RE: Submission of 2019 Geotechnical Inspection Report No. 1 (July 2019)

2019 Geotechnical Inspection Report No. 1

Annual Geotechnical Inspections – 2019 Report 1. Mary River Iron Mine Complex – Nunavut

Re: Annual Site Inspections and Reporting - Mary River Iron Mine Complex, Nunavut

Figure 6: Aerial view of the three PWS ponds

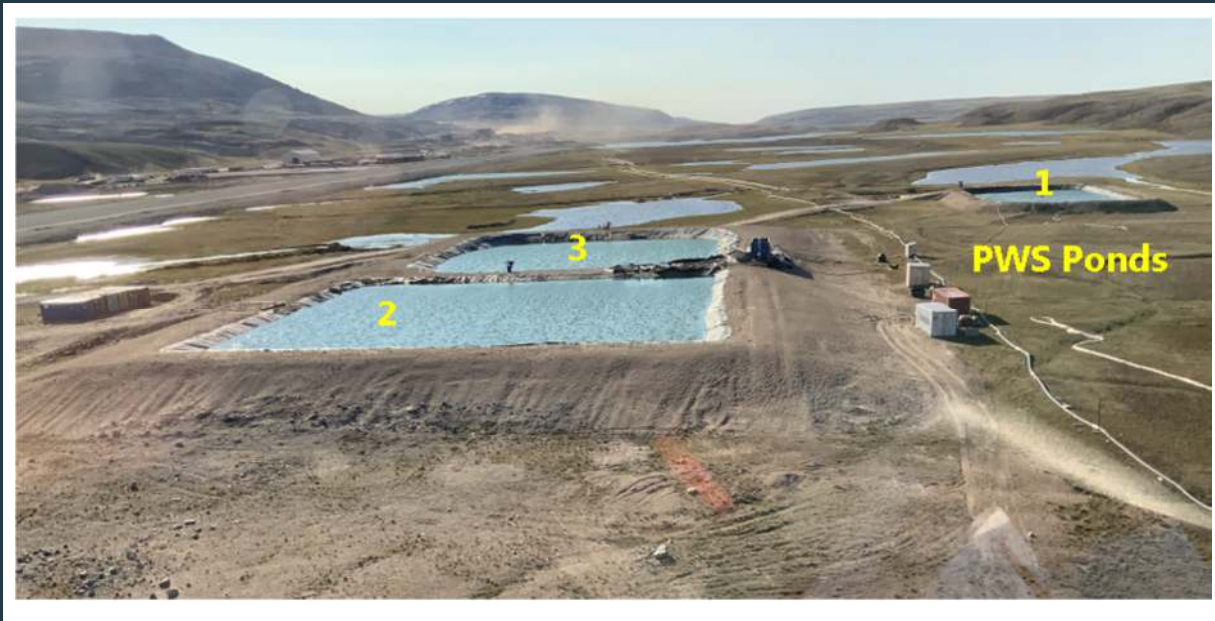
The berms around the ponds generally comprise granular soils (sand and gravel), supporting High Density Polyethylene (HDPE) geomembrane liners. The liners are secured in anchor trenches on the crest of the berms, and no damage is visible on the membranes on the upstream face of the slopes. However, there are some minor damages visible on the liners on the crest of the berms (above the maximum water/freeboard line) at a few locations, as shown in Figure 7 (see red circles). These minor damages should be repaired as part of the regular maintenance program.

As shown in Figure 6, the berms around the three ponds appear to be stable, having shallow downstream slopes. They were built by using non-frost-susceptible well compacted granular materials (dense state of compactness based on visual inspection and manual probing). Based on surficial site observations, it appears that the subgrade around the berms comprise thaw-stable granular soils with trace to some fines. With this observation, the berms are assumed to have stable foundations, which is further supported by the fact that there are no indications of differential settlements, sinkholes, sloughing, etc. at the perimeter berms. However, at a few locations truck-tire related damages (e.g., depression on the crest's surface and related densification) were observed (see yellow circles in Figures 7 and 8) at the top of the berms. These are assumed to be caused by discharging activities. It is advisable to backfill these depressions with compacted sand and gravel until these areas match the crest elevations elsewhere. Prior to fill placement all visible minor damages to the liners shall be repaired.

Baffinland Action: Baffinland commits to having the minor damage to the liner repaired as part of the regular maintenance program. Baffinland will continue to monitor the PWSPs for the presence of whales in the liner, and as needed will develop a plan to address these when the affected pond is drained. Cleanup of this area will occur to remove excess materials.

Figure 19: View of HWB-7

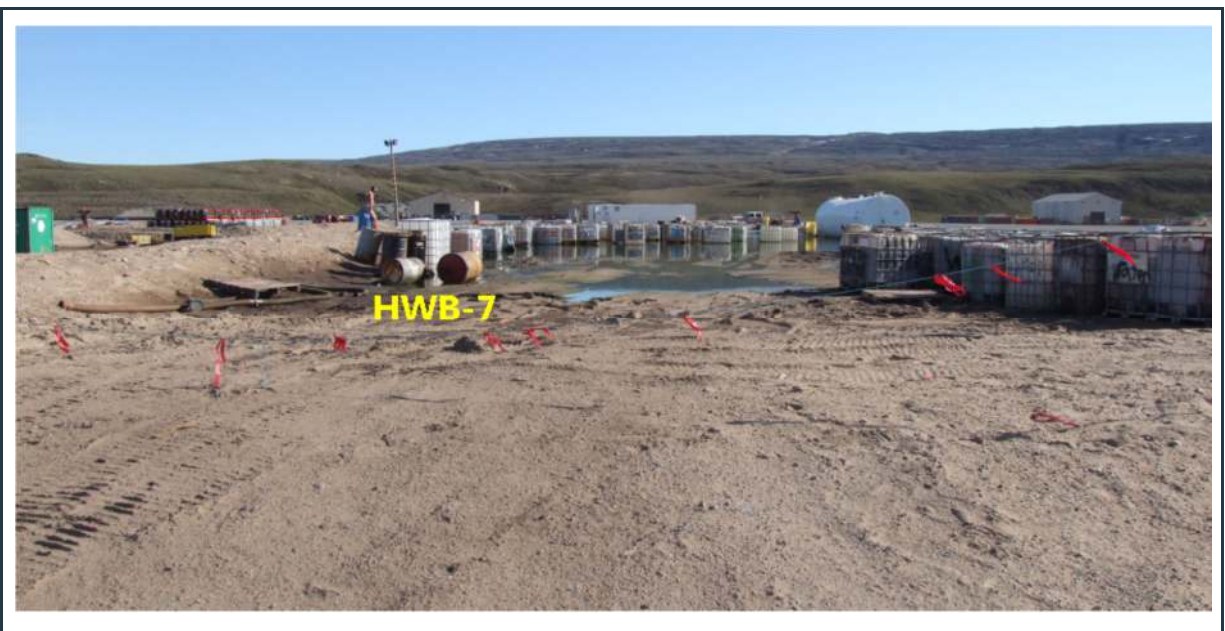
Minor damages to the geotextile (covering the liner) were noted at a few locations on the crest and downstream slope of the berm.

Based on information from historic reports, the HWB-7 cell was a bulk fuel storage facility in the past. Currently it is used to store fuel barrels, lubricant totes and a large fuel tank, as shown in Figures 18 and 19. The perimeter berm around three sides of the cell appears to be stable and the visible water within the cell supports adequate liner performance. There is a ramp along the fourth side of the cell (with appropriately high elevation at its highest end) to provide truck access into the cell.

Baffinland Action: Baffinland commits to reinstating geotextile and soil cover in the specified areas in order to prevent potential damage to the liner in the future.

Figure 49: Berm in excellent condition with stable slopes around the MP-01A pond

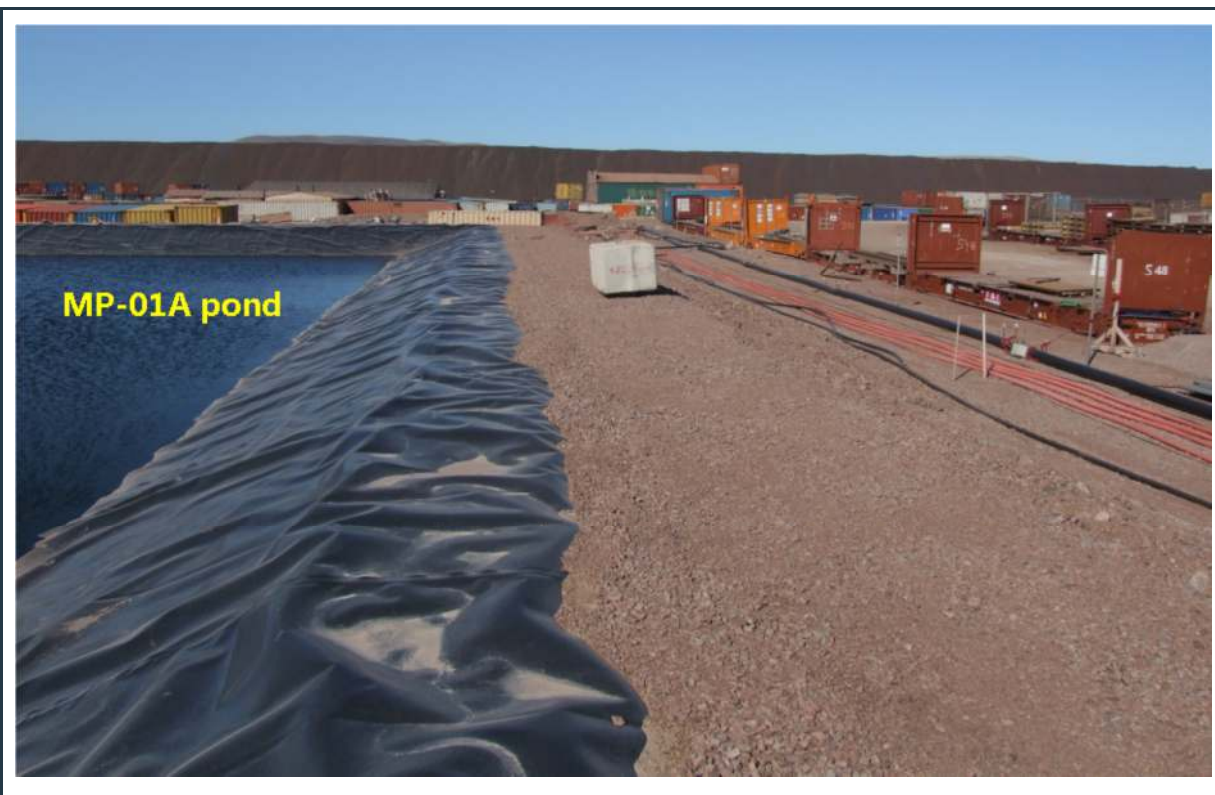
The new (2014) MP-01A polishing waste stabilization pond is located immediately south of the MP-03 fuel tank farm. As shown in Figure 49 the berm around the pond is in excellent condition and the liner appear to be intact. No sign of slope instability, settlement or seepage from the pond was noted during the field inspection.

Figure 77: View of the "old" abutments at bridge 63

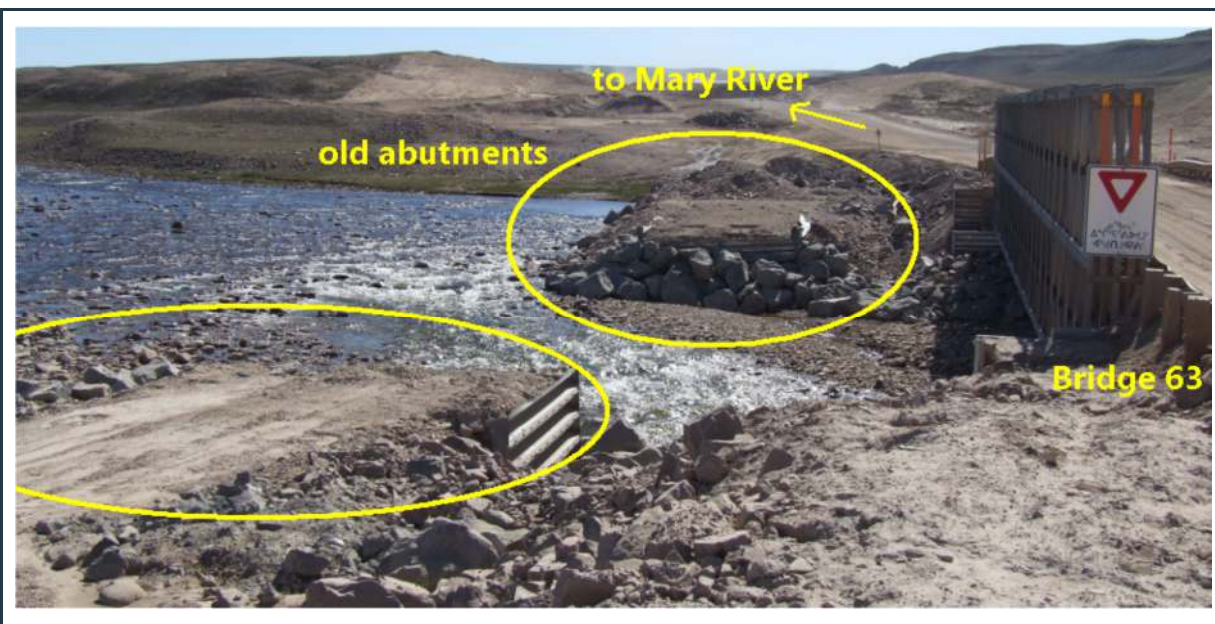
There are two historic abutments, located immediately adjacent to the “new” ones and damage to the metal front and wing walls of both abutments are visible. In order to maintain the stability of the currently used bridge abutments, the two old abutments should be kept in place since they provide support to the adjacent new structures.

maintain the stability of the currently used bridge abutments, the two old abutments should be kept in place since they provide support to the adjacent new structures. Similarly, to the previous bridge the damaged part of the structures (above the water level) can be removed and the granular fill within them regraded. Additional rip-rap on the regraded granular fill must be placed to prevent erosion.

Baffinland Action: To maintain the stability of the currently used bridge abutments, Baffinland will keep the two old abutments in place since they provide support to the adjacent new structures.
